Tweed Valley Hospital Stage 2 Modification 1

Minor design changes
State Significant Development Modification Assessment
(SSD-10353-Mod-1)

July 2021

Figure 4 | Proposed ground level with marked up changes (Base source: SSD-10353-Mod-1 Modification Report)

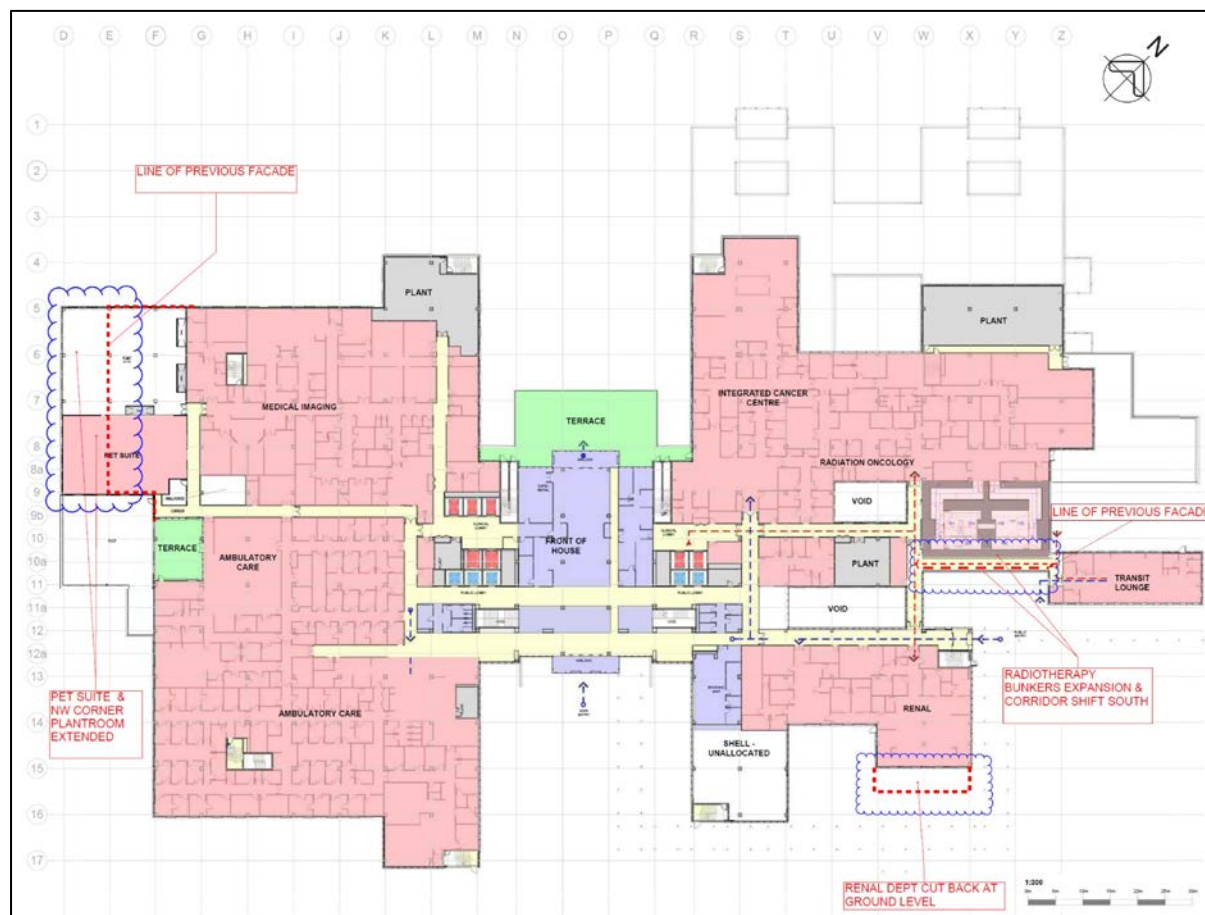
The proposal seeks approval to make multiple minor amendments to the ground level and to the ICU terrace on Level 3 and associated external façade changes. The change to the PET and plant areas would be the most significant changes with the greatest additional floor area as shown in **Figures 4, 6 and 8**. The other changes are relatively minor or reduce the size of the development.

- there is no significant change to the overall bulk of the building given that the relatively minor above ground expansions are generally offset by the reductions, and that the minor changes are not visually discernible from the public domain.

- the most notable increase in floor area for plant would have negligible amenity impacts due to its basement location and the increase is required to support the servicing of the hospital.

- the ground floor amendments increase the GFA by 238sqm, resulting in a total GFA of 64,900sqm after removing basement plant area from GFA calculations, which complies with the 65,050sqm prescribed in the concept proposal.

- the minor increase in GFA would have negligible impacts given the relatively small increase of less than one per cent of the overall GFA and the proposal is still located within the approved building envelope.

- the façade changes are in keeping with the style and character of the building and utilise colours and materials that are approved for the hospital.

The Department therefore considers the design changes are acceptable and would not result in any adverse visual, aesthetic or amenity impacts. The proposed development as modified is acceptable as patient and staff numbers would stay the same and there would be no reduction in medical services.

Figure 9 | Approved and proposed HV compound (Base source: SSD-10353 Approved Plans and SSD-10353-Mod-1 Modification Report)

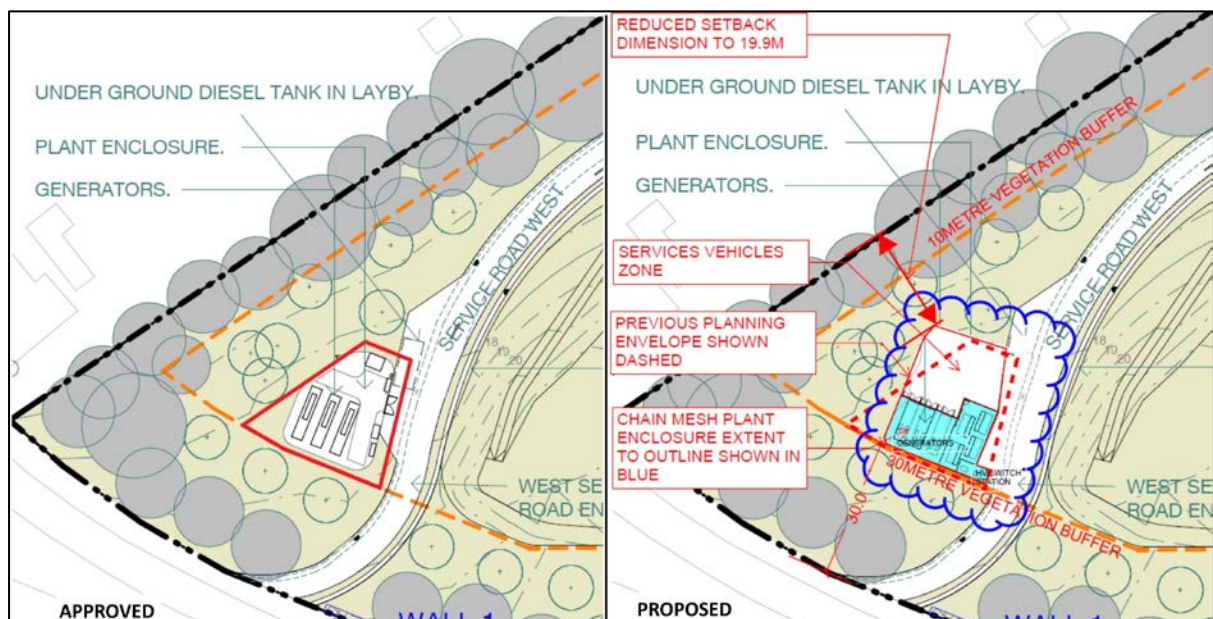
The modifications to external areas are generally located centrally or setback from the site frontage, except the reconfiguration of the site generator and HV switch station enclosure, which are located in the south of the site, adjoining the southern and western boundary and potentially visible from Cudgen Road. The modifications involve an increase to the hardstand area for servicing the compound, which is partially located outside of the approved area identified in the concept proposal and located closer to the western site boundary.

Council noted that this would reduce the potential vegetative buffer zone but the proposed use would not result in any impacts on the adjoining agricultural use.

The Department considers that the modifications are acceptable as the reconfigured compound remains located outside of the 30m and 10m vegetative buffer zones to the respective southern and western boundaries required by the approved concept proposal. The setback of plant and equipment to the boundaries remains the same and the associated changes to landscaping and roadway are generally consistent with the existing approved scheme.

Figure 10 | Approved and proposed SPS with additional tank (Base source: SSD-10353 Approved Plans and SSD-10353-Mod-1 Modification Report)

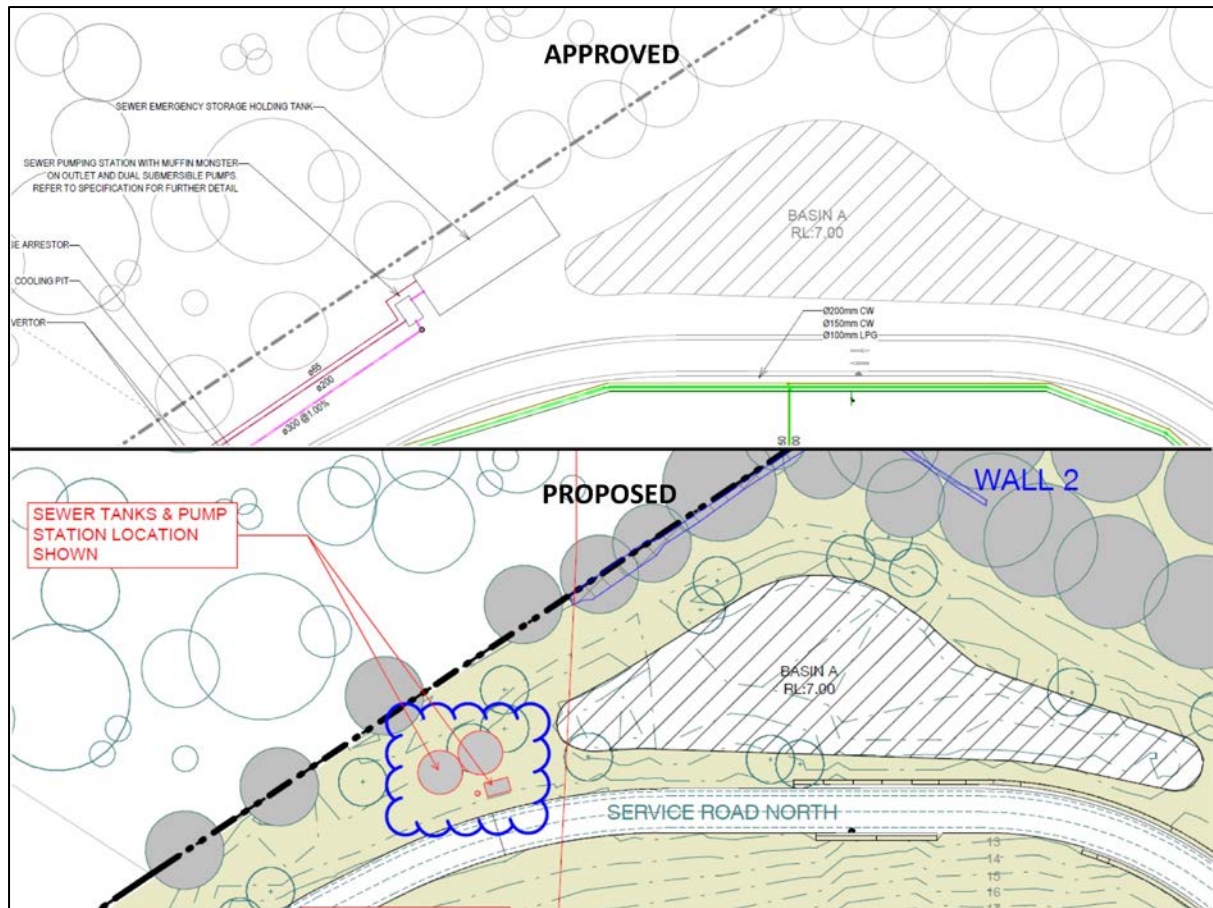
The modification request seeks approval for relocation of the SPS station further north of the current location and an additional overflow tank as shown in **Figure 10**. These changes are consistent with the approval for the SPS issued by Council. The SPS is located outside of any vegetative buffers and

would generally have minor impacts but results in the loss one tree in the proposed landscaping. This would not affect the significant vegetation being retained on the site. The Department has considers the loss of one tree is acceptable.

Figure 11 | Approved and proposed CEP area (Base source: SSD-10353 Approved Plans and SSD-10353-Mod-1 Modification Report)

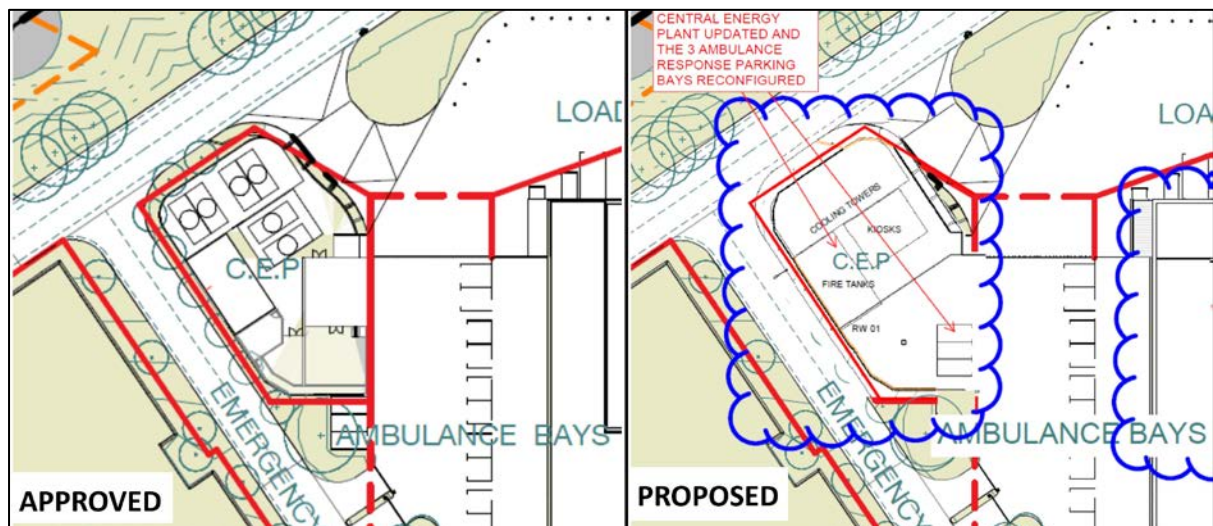
The proposal seeks approval to reconfigure the layout of the CEP area (see **Figure 11**) which is centrally located. The Department considers the changes would have negligible impacts.

The Department also considers the proposed changes are acceptable as they would improve the functionality of the hospital.
